## HPC-23-04

February 15, 2023

**To:** Historic Preservation Commission  
**From:** Wade Broadhead, Senior Planner  
**Through:** Scott Hobson, Acting Director of Planning and Community Development  
**Location:** 201 Lamkin St, Unit 410  
**Applicant:** Ron Guarienti  
**Owner:** Same  
**Year Built:** 1910-1920  
**Legal Description:** Lot 4, Block 58, South Pueblo  
**Zone District:** HB, Historic Business Zone District

### Synopsis

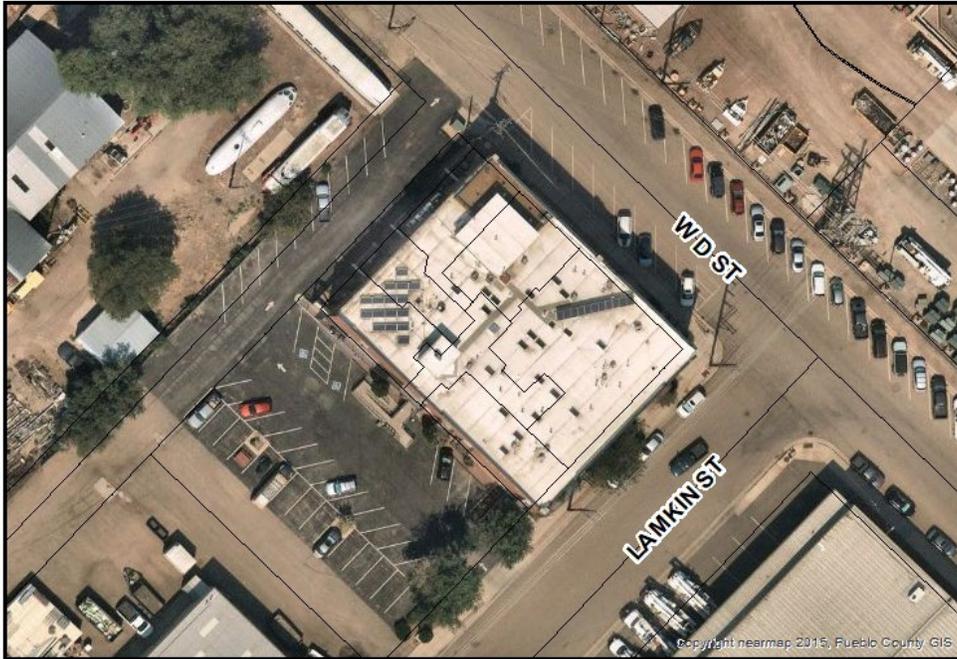
Affirmative finding: the Lamkin Building is not on any level of historic register and is situated two blocks from the Union Avenue National Register Historic District. The addition does not impact any adjacent historic buildings. The adjacent Pueblo 5 and 6 Power Plant is locally landmarked and is much taller and industrial in nature.
